Cable Assembly TP1-TP4 Insertion Loss (Comment #358)

Week of Sept 15, 2025

TE Connectivity

Comment #358

Current TP1-TP4 Loss Budgets

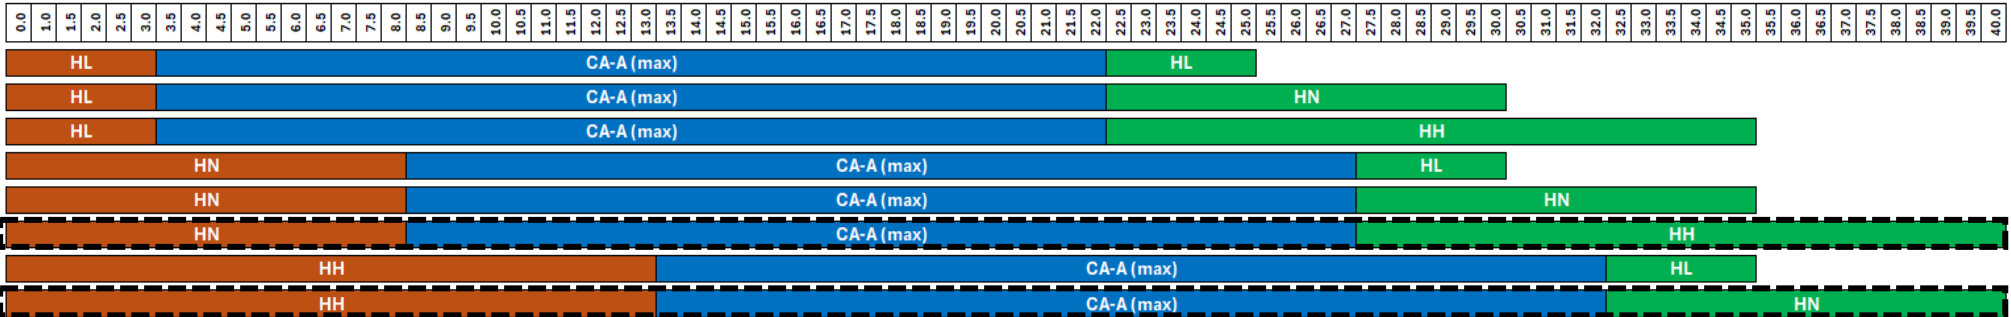
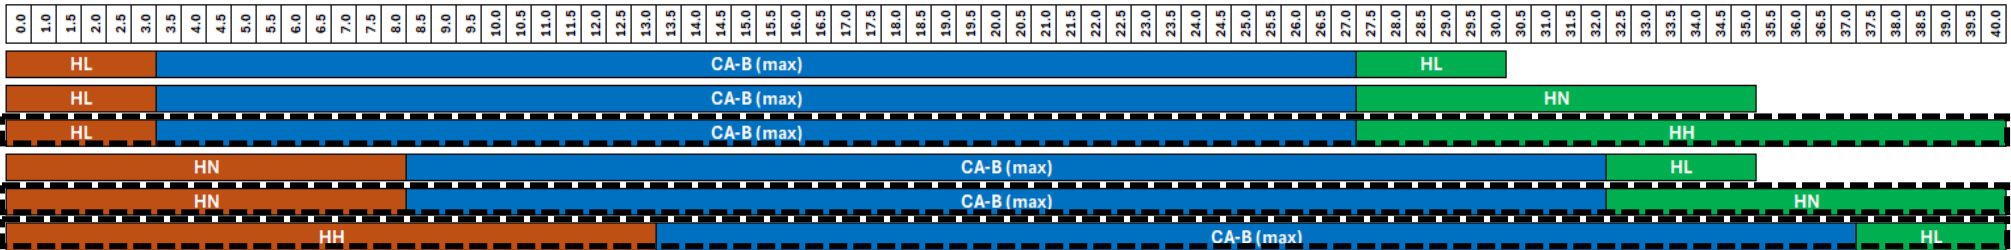
- 3 host classes. HL = 3 dB, HN = 8 dB, HH = 13 dB (maximum)
 - These are partial host losses. The full host loss includes an additional 5.95 dB that includes the reference packages and additional host PCB trace.
 - Full host loss: HL/HN/HH = 8.95/13.95/18.95 dB (maximum)
- 4 Cable Assy classes: CA-A = 19 dB, CA-B = 24 dB, CA-C = 29 dB, CA-D = 34 dB (maximum)
- The 40 dB total budget (die to die) constrains the allowed combinations of hosts and cable assemblies.

1.0m 26AWG & 1.0m 25AWG DAC, S_{DD21} @ 53.12GHz

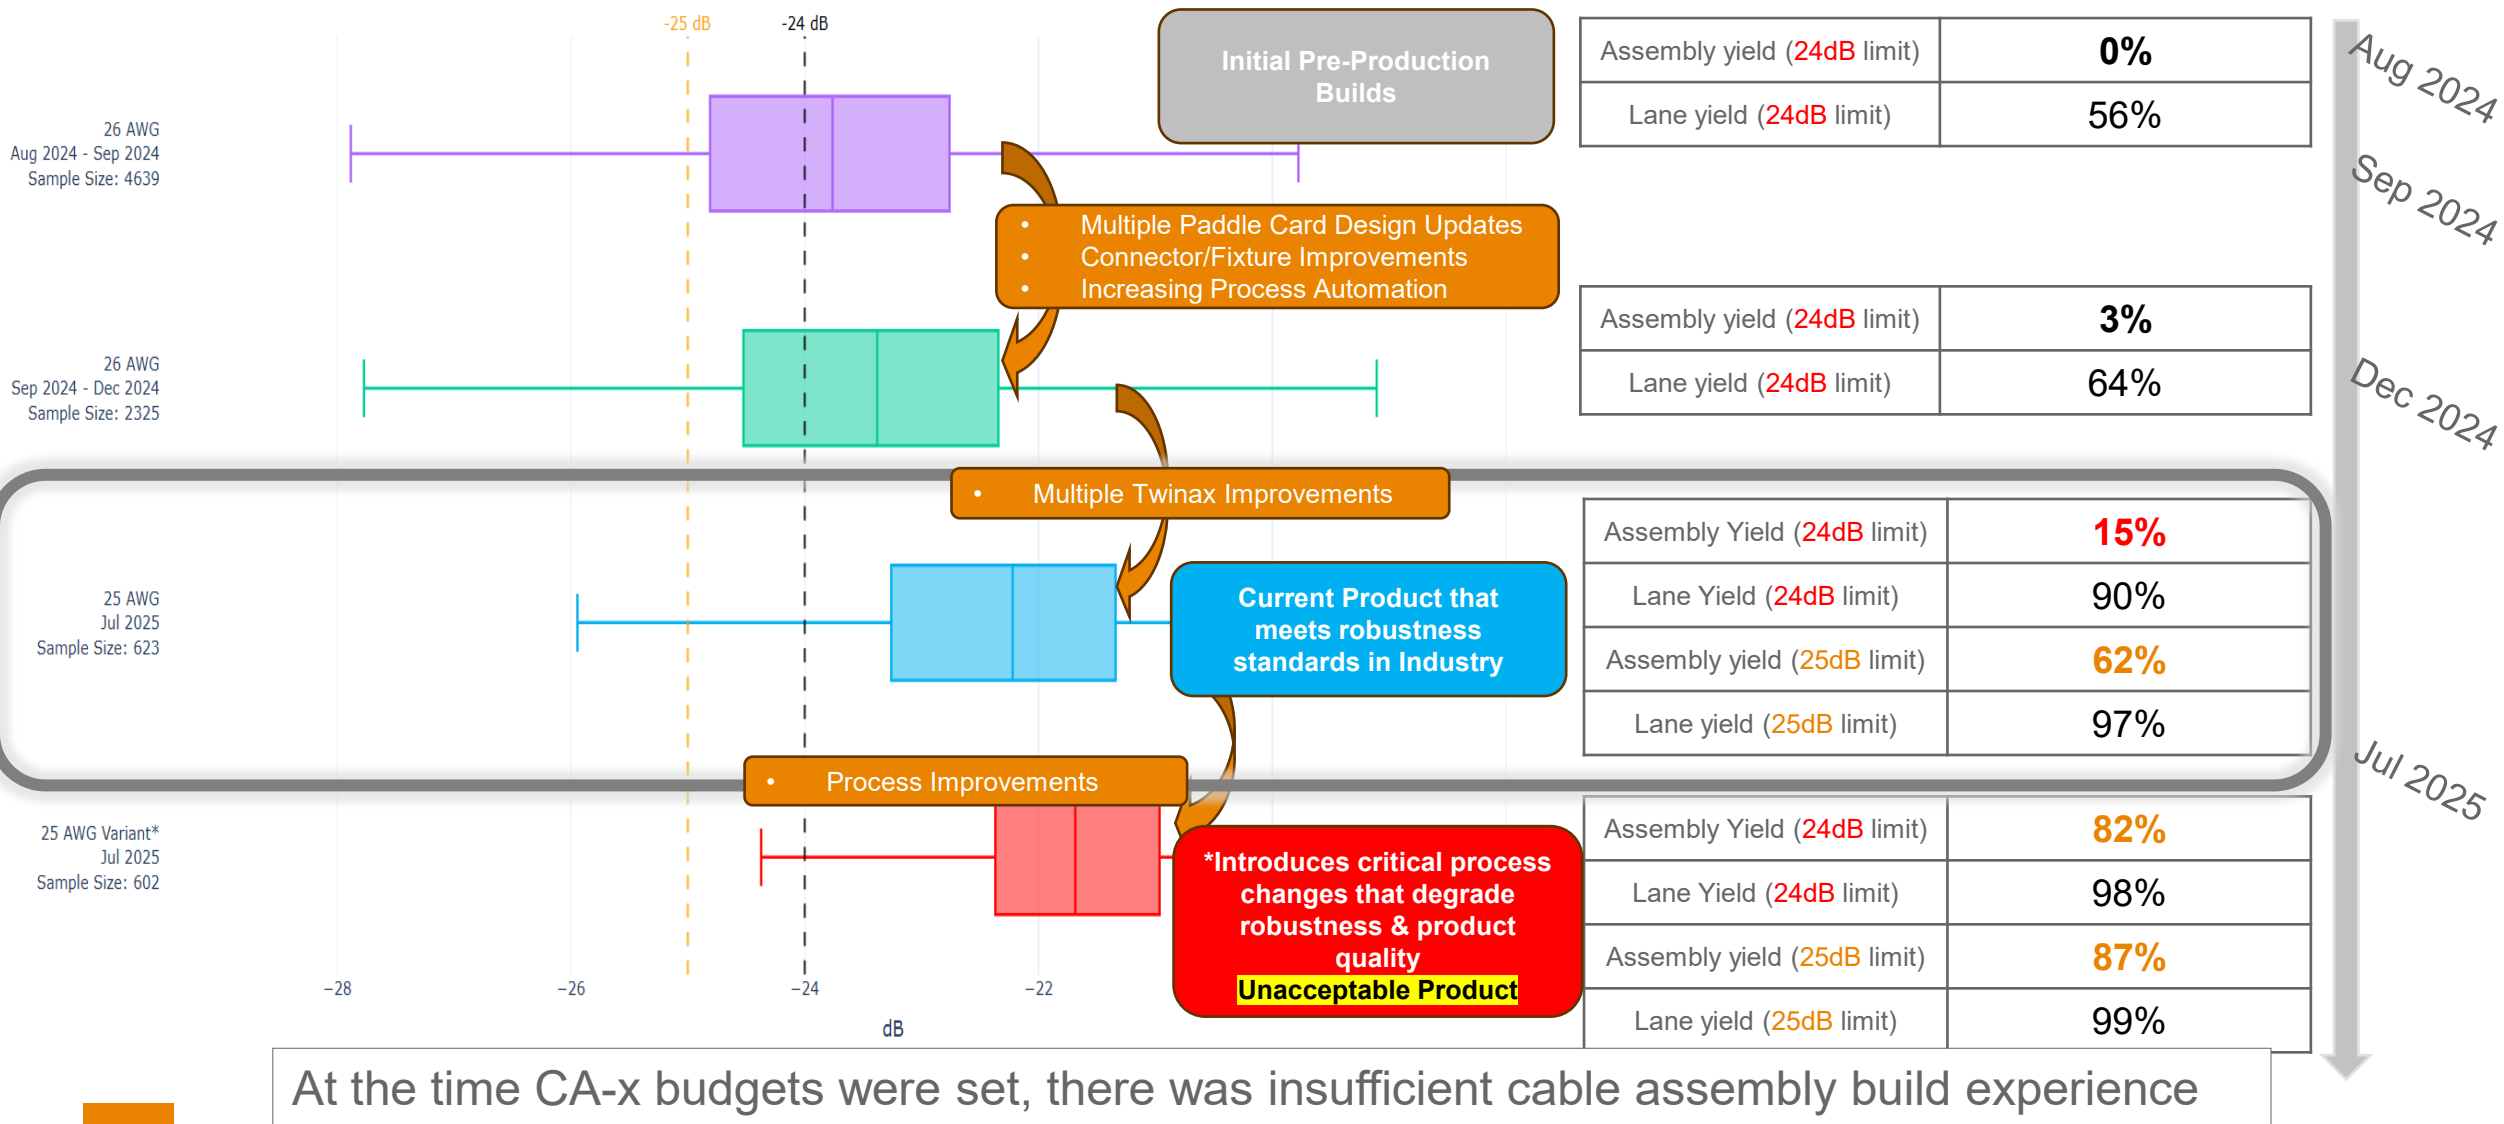
Cable assembly TP1-TP4 insertion loss specifications prove challenging to meet when accounting for all sources of variation, specifically for the CA-A and CA-B cable assembly classes. A more manufacturable specification needs an additional 1 dB insertion loss to be allocated to the cable assembly for CA-A and CA-B.

Limiting case

- Reduce the insertion loss allocation for all three host classes (HL/HN/HH) by 0.5 dB (Table 179A-1).
- Increase the TP1-TP4 cable assembly insertion loss (Table 179-14) for CA-A from 19 dB to 20 dB, and for CA-B from 24 dB to 25 dB.
- Change the partial host PCB trace lengths in Table 179-19 to provide the host loss reduction
 - (see slides 10-11 for full implementation details)

TP1-TP4 Loss Budgets with Proposed Changes

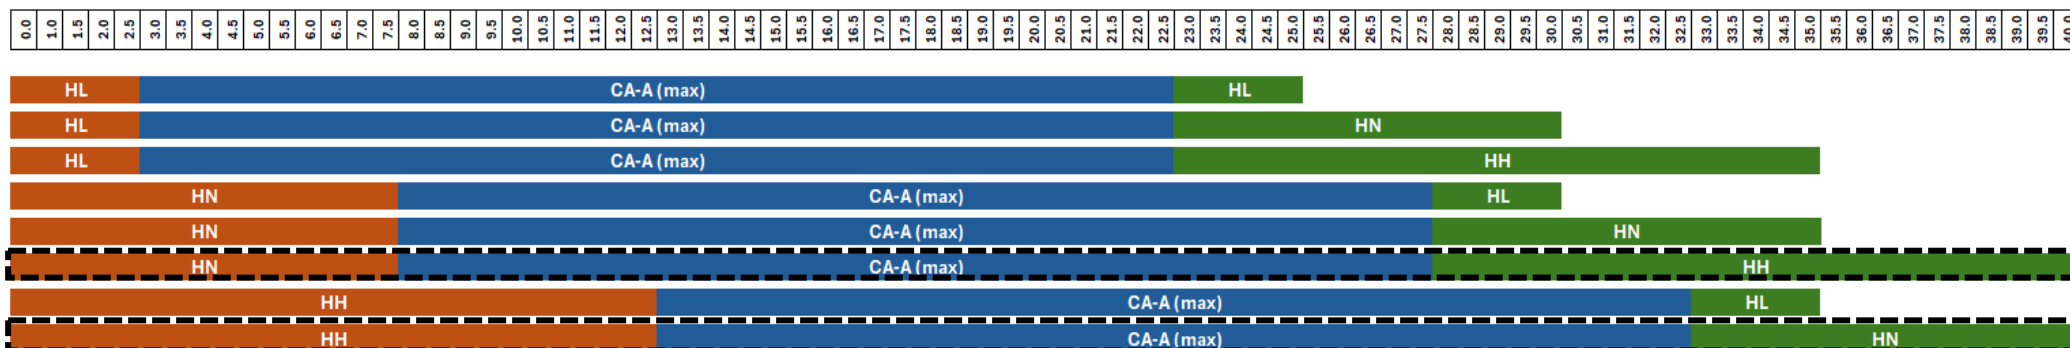
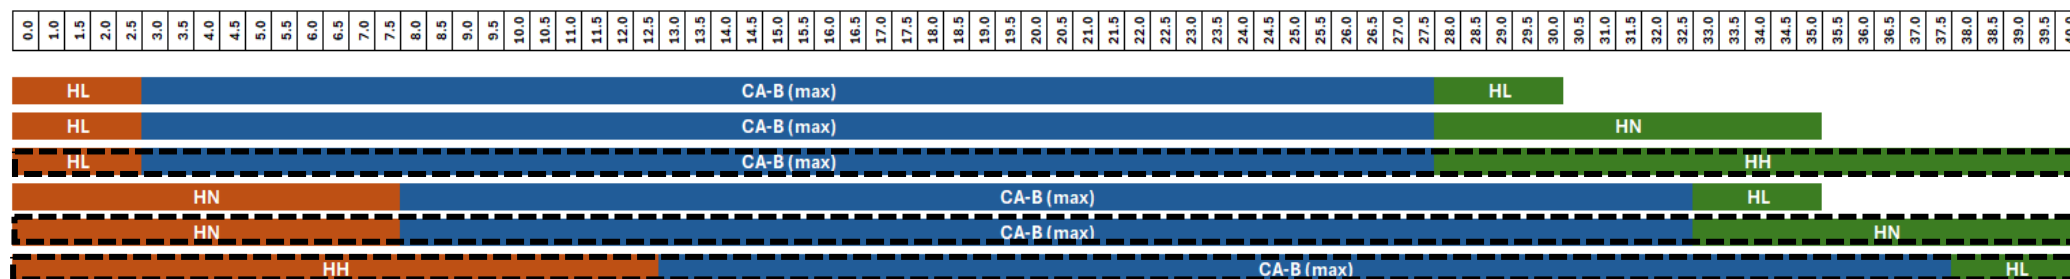
- Needs: Reduce combined host loss by 1 dB.

- Proposed partial host & CA insertion loss:
 - HL = 2.5 dB, HN = 7.5 dB, HH = 12.5 dB
 - CA-A = 20 dB, CA-B = 25 dB, CA-C = 29 dB, CA-D = 34 dB
- Host physical design impact: Assume all reduction from host PCB (no change to pkg).
 - 0.5 dB IL reduction ~10 mm trace length reduction on each host
 - Depends on dielectric material, surface roughness and stackup/trace geometry

Figure 179A-1—Host-Nominal to Host-Nominal, Cable assembly, and test fixture insertion loss at 53.125 GHz

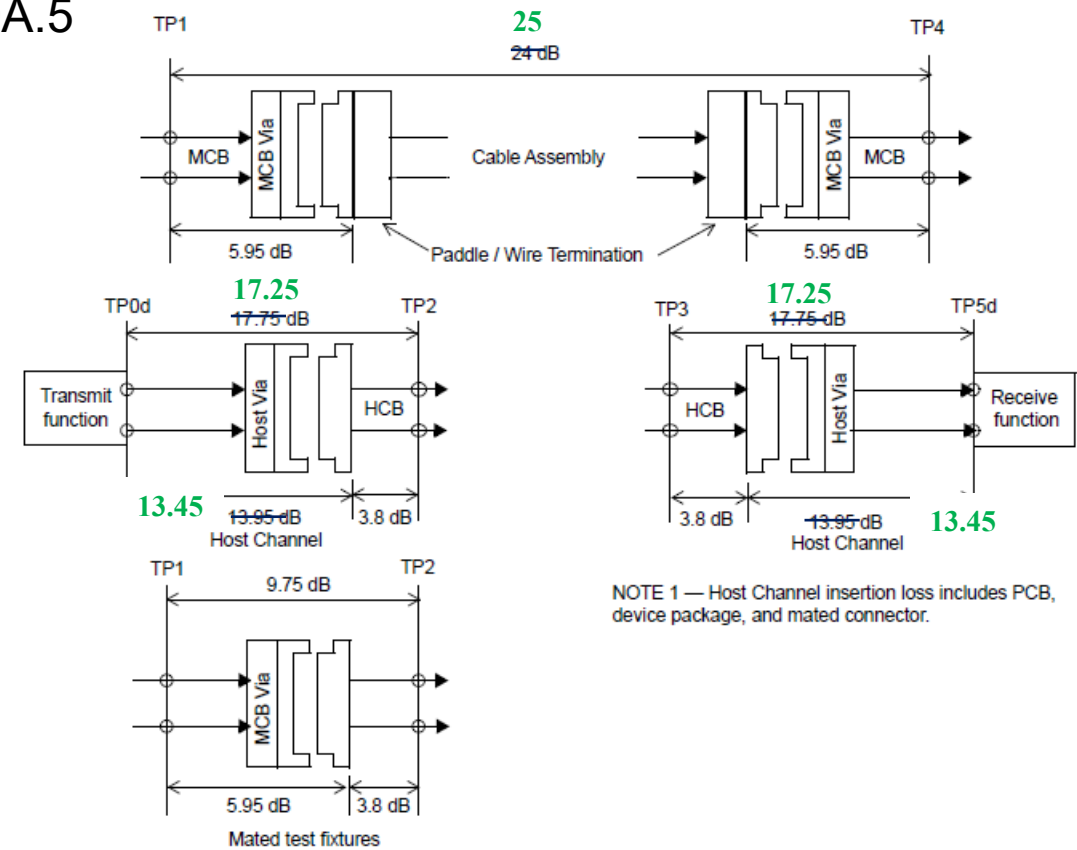
- MCB = Module Compliance Board, 179B.3
- HCB = Host Compliance Board, 179B.2
- MCB Via = transition via to MDI connector on an MCB
- Host Via = transition via to MDI connector on a Host Channel
- Paddle/Wire Termination = transition structure(s) in a Cable Assembly not present on an HCB

Figure 179A-2—HN-to-HN Channel Max (TP0d-TP5d) at 53.125 GHz

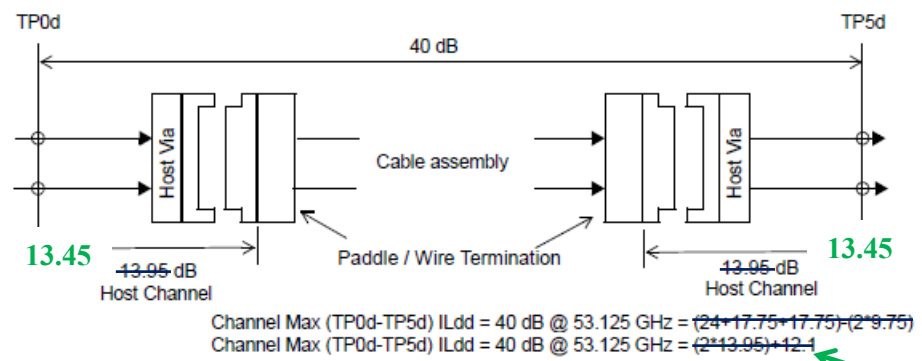
Channel Max (TP0d-TP5d) ILdd = 40 dB @ 53.125 GHz = (25+17.25+17.25)-(2*9.75)
 Channel Max (TP0d-TP5d) ILdd = 40 dB @ 53.125 GHz = (2*13.45)+13.1
